Bid No. 09-CP-67

Urbana District Park

Addendum No. 2

Bid Number 09-CP-67
Urbana District Park
Addendum No. 2

Detail 24 – Stabilized Construction Entrance

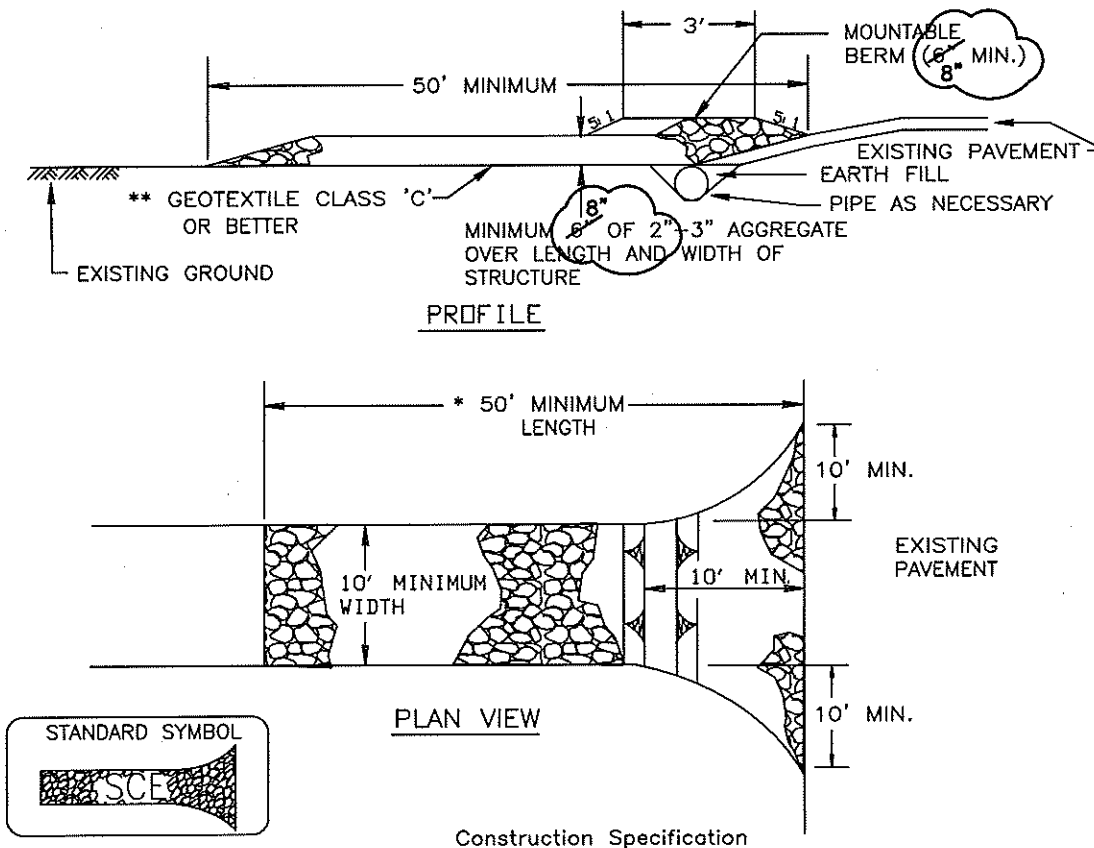
DETAIL 24 - STABILIZED CONSTRUCTION ENTRANCE

1. Length - minimum of 50' (*30' for single residence lot).
2. Width - 10' minimum, should be flared at the existing road to provide a turning radius.
3. Geotextile fabric (filter cloth) shall be placed over the existing ground prior to placing stone. **The plan approval authority may not require single family residences to use geotextile.

4. Stone - crushed aggregate (2" to 3") or reclaimed or recycled concrete equivalent shall be placed at least 8" deep over the length and width of the entrance.

5. Surface Water - all surface water flowing to or diverted toward construction entrances shall be piped through the entrance, maintaining positive drainage. Pipe installed through the stabilized construction entrance shall be protected with a mountable berm with 5:1 slopes and a minimum of 6" of stone over the pipe. Pipe has to be sized according to the drainage. When the SCE is located at a high spot and has no drainage to convey a pipe will not be necessary. Pipe should be sized according to the amount of runoff to be conveyed. A 6" minimum will be required.

6. Location - A stabilized construction entrance shall be located at every point where construction traffic enters or leaves a construction site. Vehicles leaving the site must travel over the entire length of the stabilized construction entrance.
